MWO 9-2320-273-20-1

M O D I F I C A T I O N W O R K O R D E R

TRUCK TRACTOR, LINE HAUL,
50,000 GVWR, 6 X 4, M915 (NSN 2320-01428-4395)

1. **PURPOSE.** This modification consists of procedures to add a new air tank to the compressed air system.

FIGURE 15

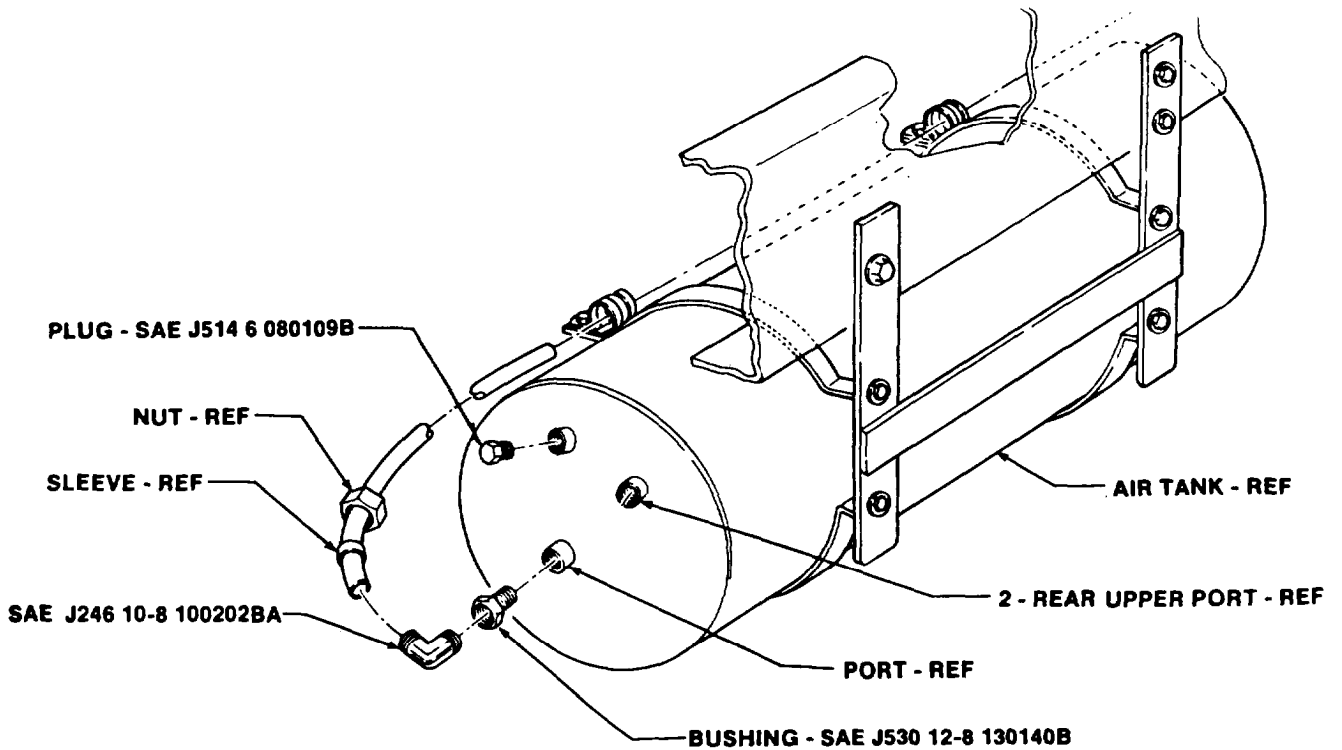
(12) Install two SAE J5146080109B plugs in rear upper ports on air tank as shown in figure 15.

(13) Install SAE J530 12-8130140B bushing in port on rear of air tank as shown in figure 15.

(14) Install SAE J246 10-8 100202BA elbow assembly in bushing on air tank as shown in figure 15. Retain sleeve and nut for use in step 18.

FIGURE 16

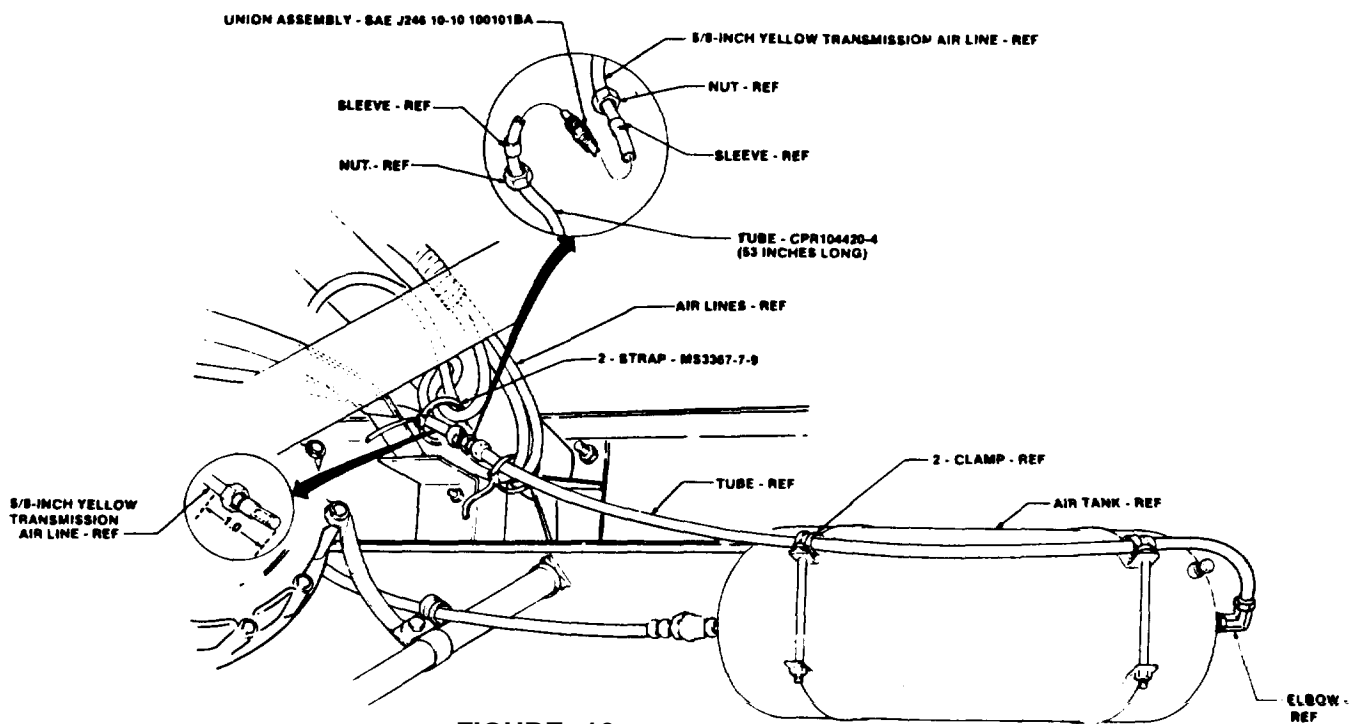
(15) Cut off one inch of existing 5/8-inch yellow transmission airline as shown in figure 16, and discard fitting.

(16) Install SAE J246 10-10100101BA union assembly on 5/8-inch yellow transmission air line and secure with sleeve and nut as shown in figure 16. Retain sleeve and nut for use within step 17.

(17) Install CPR104420-4 (53 inches long) tube on union assembly and secure with sleeve and nut as shown in figure 16.

(19) Install two MS3367-7-9 straps around airlines as shown in figure 16.

FIGURE 1

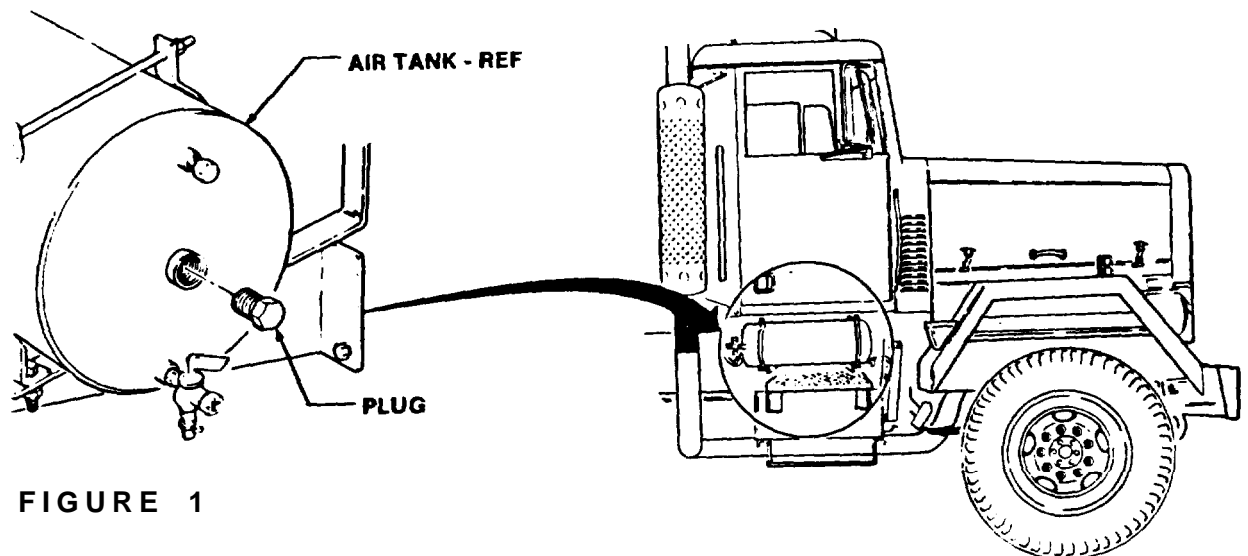
- (1) Drain air system (refer to TM 9-2320-273-10).
- (2) Remove plug from front of air tank as shown in figure 1.

FIGURE 2

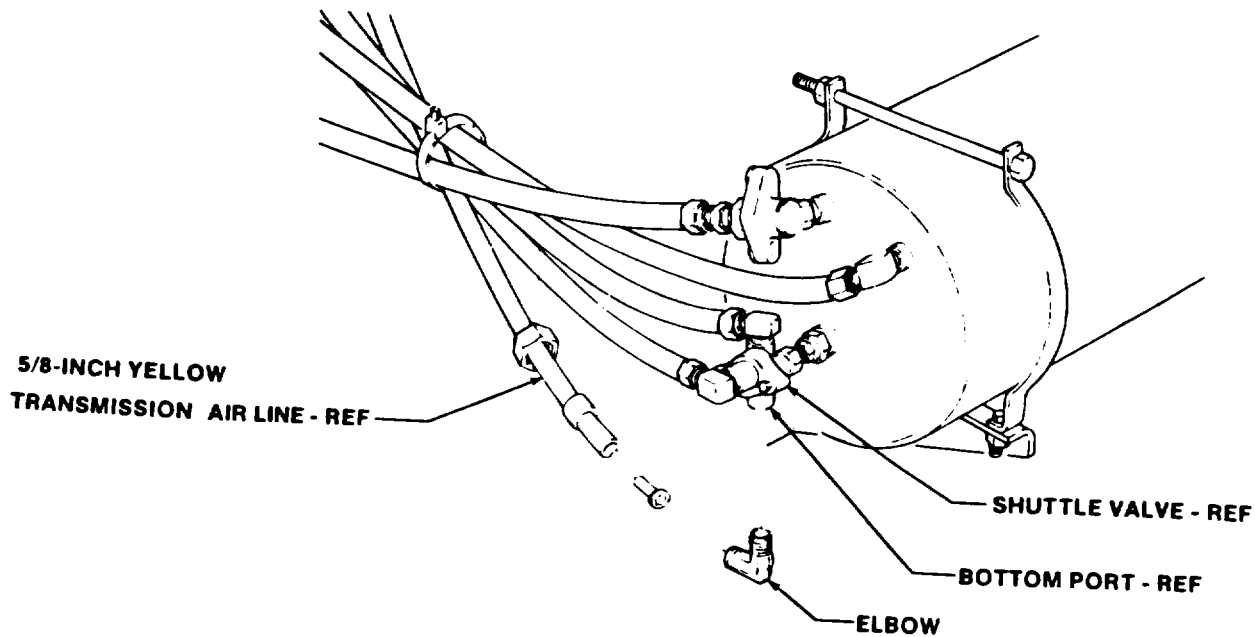
(3) Remove 5/8-inch yellow transmission air line from elbow on shuttle valve as shown in figure 2.

(4) Remove elbow from bottom port on shuttle valve as shown in figure 2.

FIGURE 3

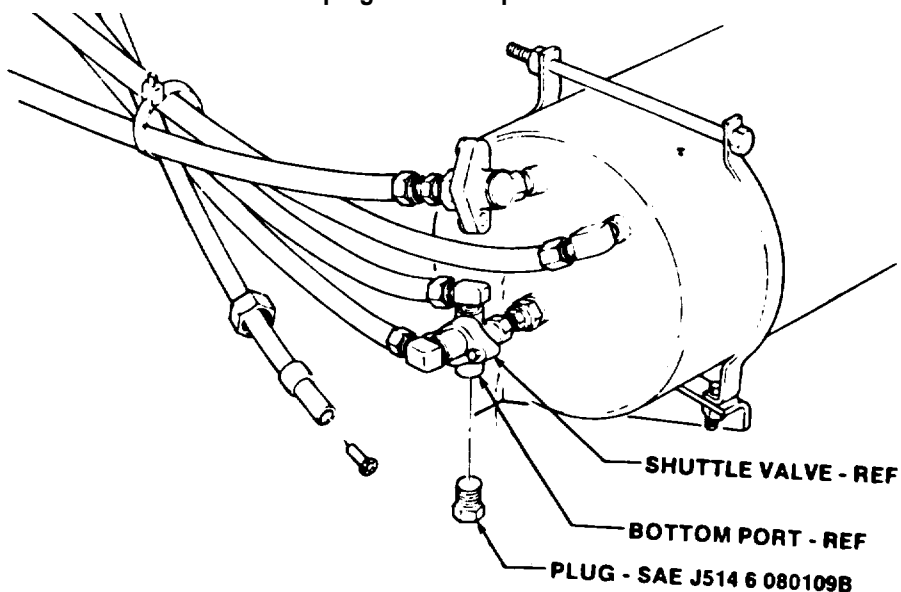
(5) Install SAE J514 6080109B plug in bottom port of shuttle valve as shown in figure 3.

FIGURE 4

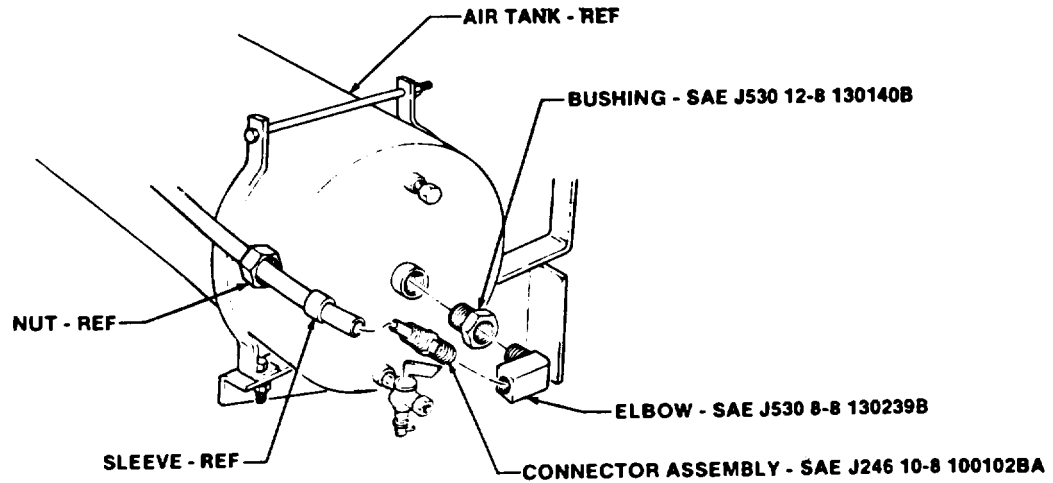
- (6) Install SAE J530 12-8 130140B bushing in air tank as shown in figure 4.
- (7) Install SAE J530 8-8 130239B elbow in bushing on air tank as shown in figure 4.
- (8) Install SAE J246 10-8 100102BA connector assembly in elbow as shown in figure 4. Retain sleeve and nut for use in paragraph b. step 8.

FIGURE 5

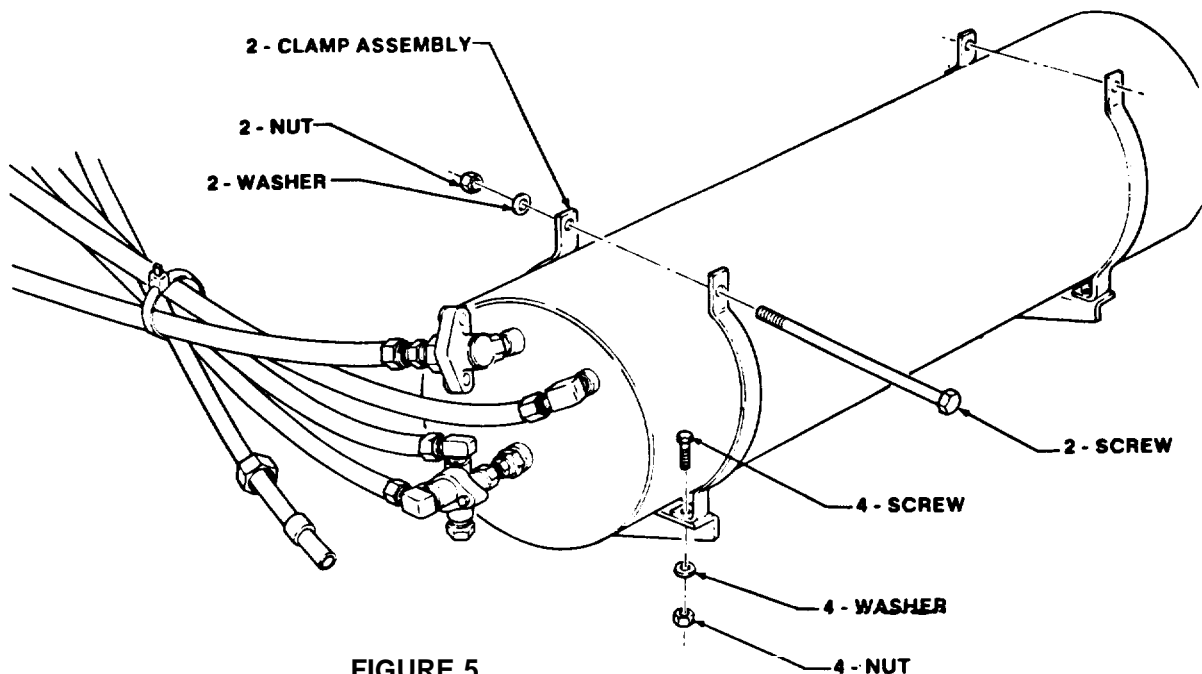
- (9) Remove two nuts, washers, and screws from two clamp assemblies as shown in figure 5.
- (10) Remove four nuts, washers, and screws from two clamp assemblies and remove clamp assemblies as shown in figure 5.

FIGURE 6

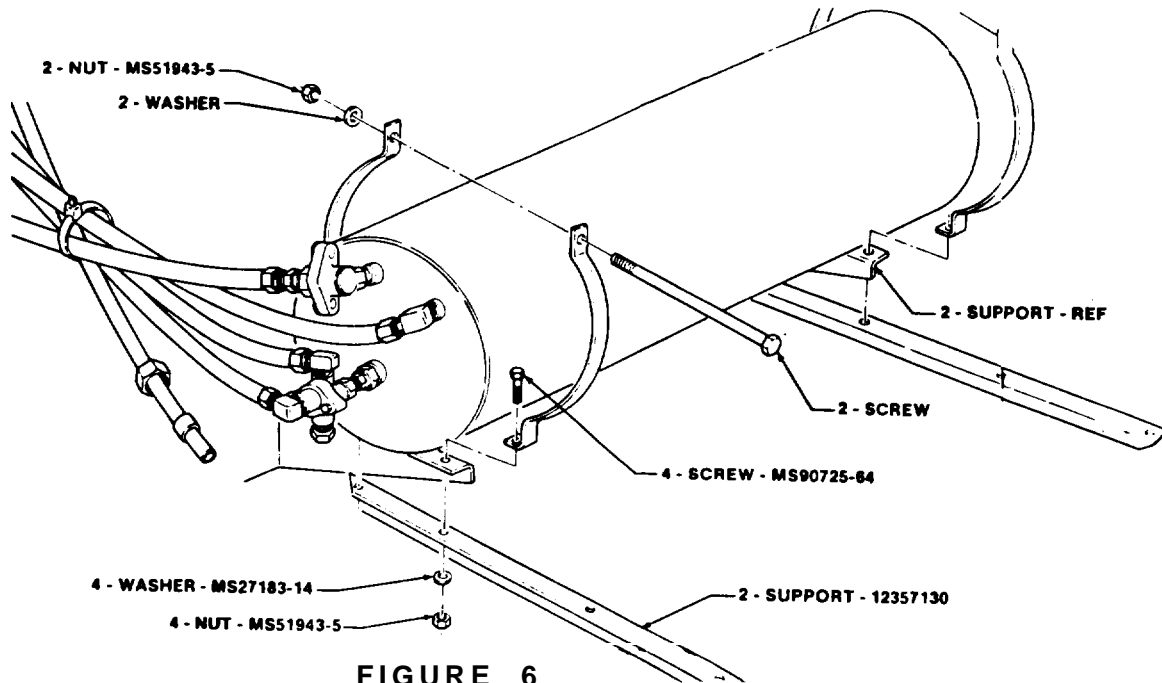
(11) Install two 12357130 supports and two existing clamp assemblies to two existing supports and secure with four MS90725-64 screws, MS27183-14 washers, and MS51943-5 nuts as shown in figure 6. Tighten nuts finger tight.

(12) Install two screws, clamps, washers (removed in step 9), and MS51943-5 nuts as shown in figure 6. Tighten nuts finger tight.

FIGURE 7

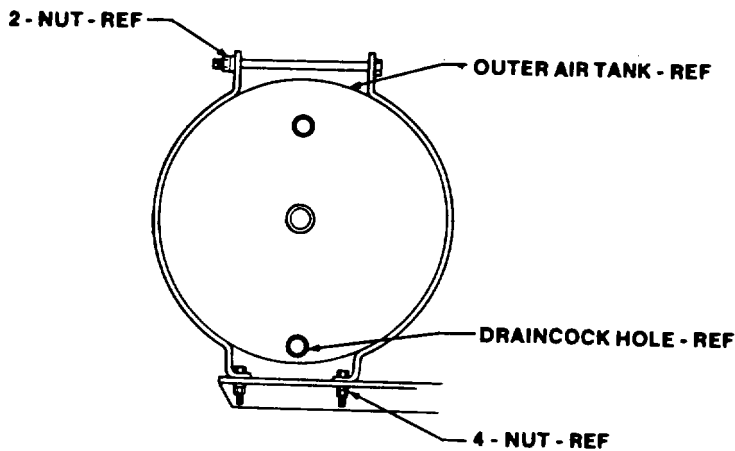
When installing the air tank on the supports, ensure it is positioned as shown in figure 7.

FIGURE 8

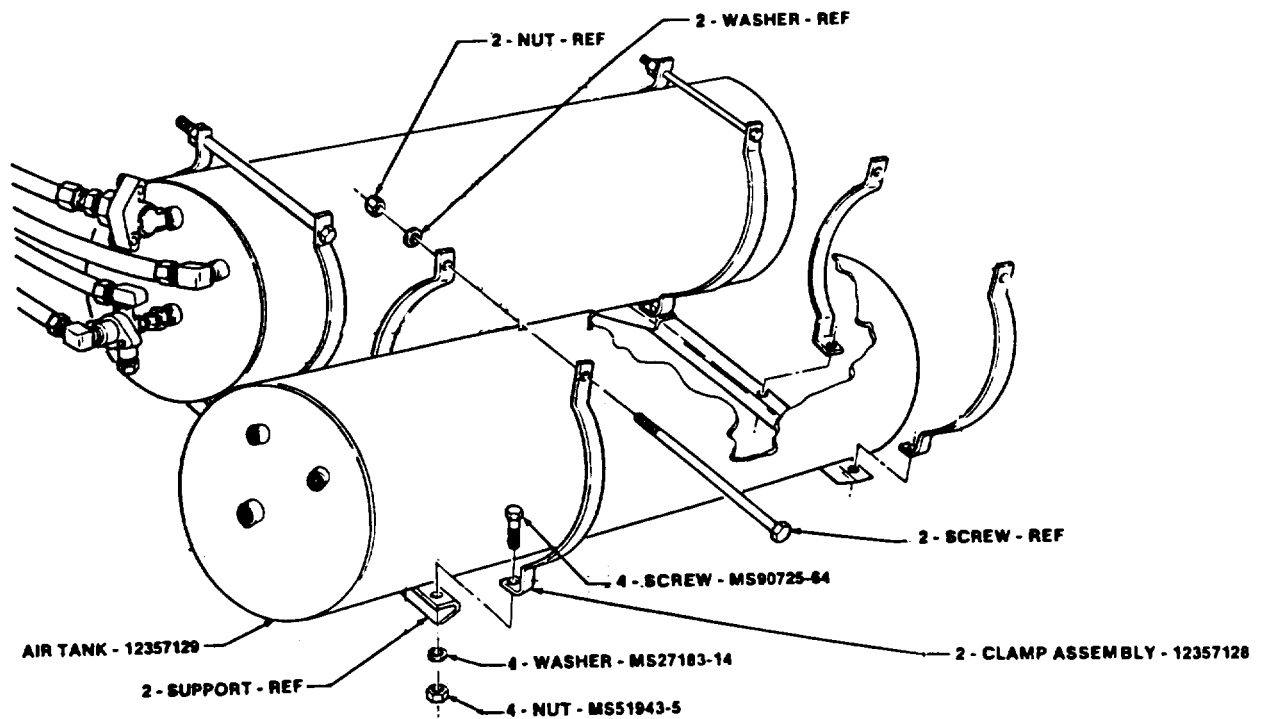
(1) Install 12357129 air tank and two 12357128 clamp assemblies to two supports and secure with four MS90725-64 screws, MS27183-14 washers, and MS51943-5 nuts as shown in figure 8. Tighten nuts finger tight.

(2) Install two screws through two clamps and secure with two washers and nuts as shown in figure 8. Tighten nuts finger tight.

FIGURE 9

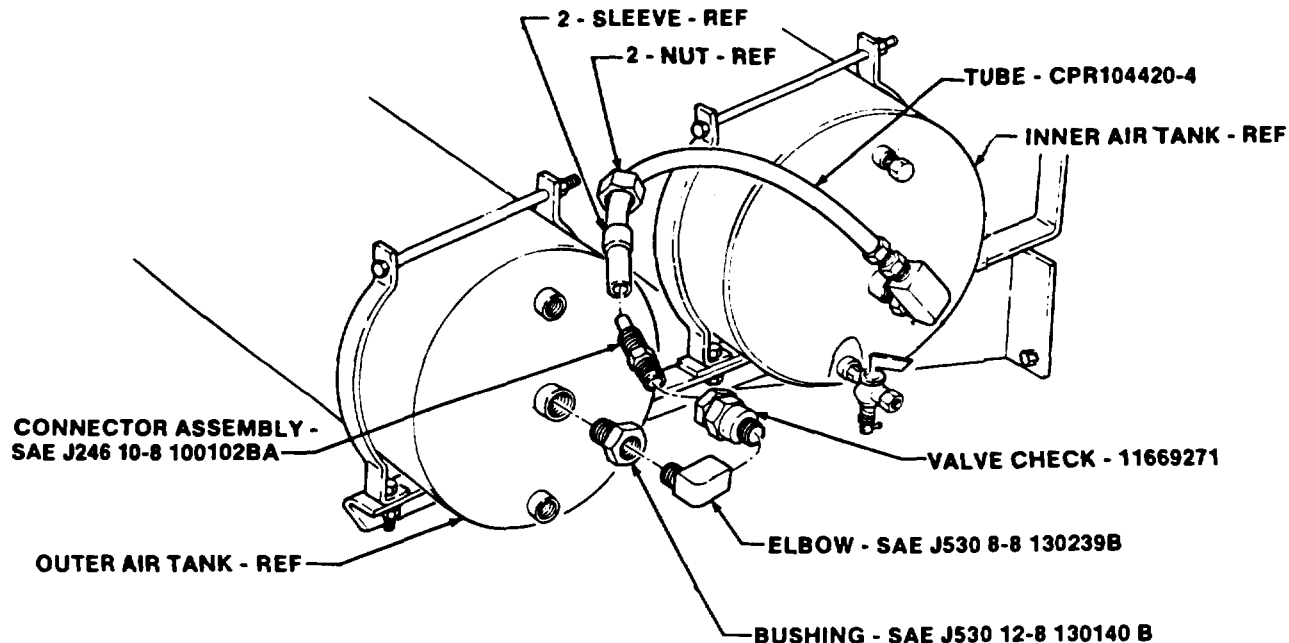
(4) Install SAE J530 12-8 130140B bushing in forward end of outer air tank as shown in figure 9.

(5) Install SAE J530 8-8 130239B elbow in bushing on outer air tank as shown in figure 9.

(6) Install 11669271 check valve in elbow on outer air tank as shown in figure 9.

(7) Install SAE J246 10-8 100102BA connector assembly in check valve on outer air tank as shown in figure 9. Retain sleeve and nut for use in step 8.

(8) Install CPRI044204 tube to inner and outer air tanks and secure with two sleeves and nuts as shown in figure 9.

FIGURE 10

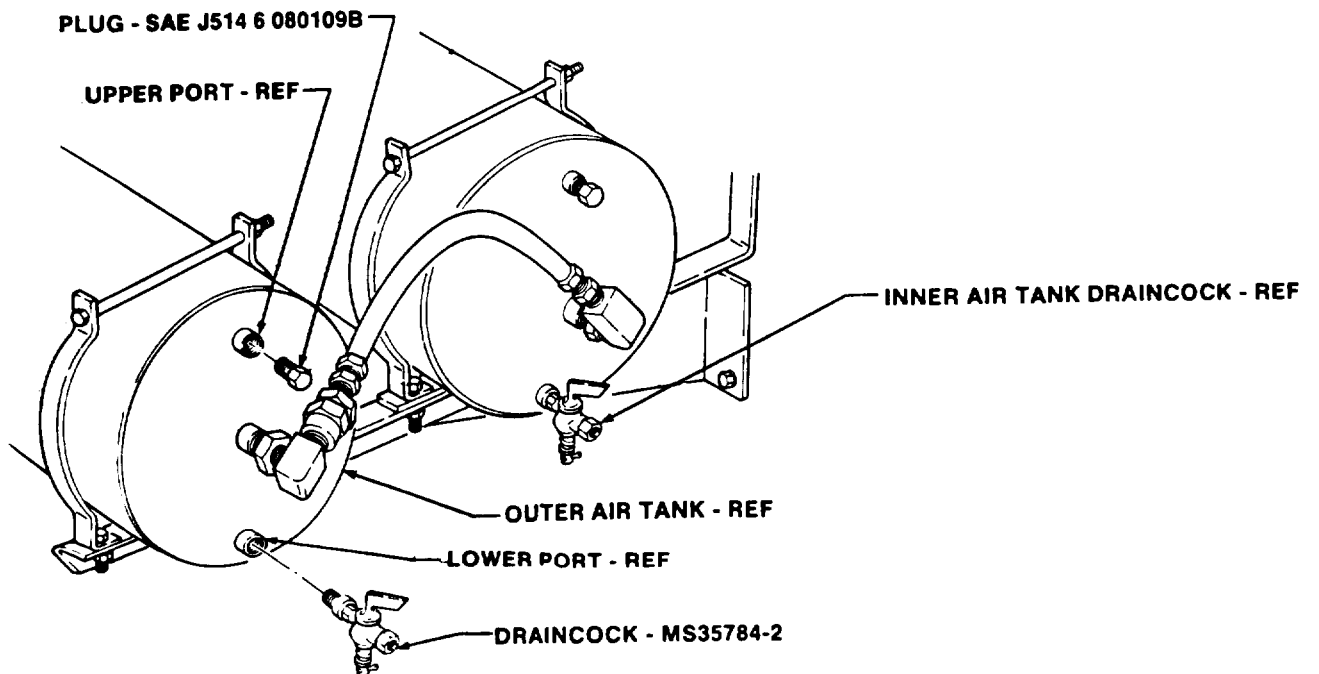
(9) Install SAE J514 6 O80109B plug in upper port on outer air tank as shown in figure 10.

(10) Install MS35784-2 draincock in lower port on outer air tank as shown in figure 10.

FIGURE 11

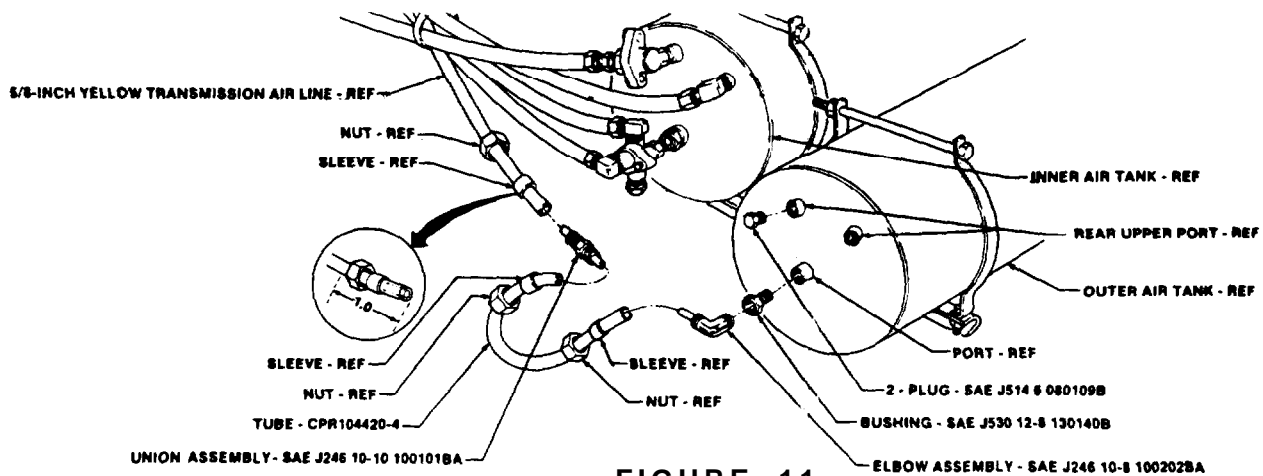
(11) Install two SAE J514 6080109B plugs in rear upper ports on outer air tank as shown in figure 11.

(12) Install SAE J530 12-8 130140B bushing in port on rear of outer air tank as shown in figure 11.

(13) Install SAE J246 10-8 100202BA elbow assembly in bushing on outer air tank as shown in figure 11. Retain sleeve and nut for use in step 17.

(14) Cut off one inch of existing 5/8-inch yellow transmission airline as shown in figure 11, and discard fitting.

(15) Install SAE 1246 10-10100101BA union assembly on 5/8-inch yellow transmission airline and secure with sleeve and nut as shown in figure 11. Retain sleeve and nut for use in step 16.

(16) Install CPR104420-4 tube on union and secure with sleeve and nut as shown in figure 11.
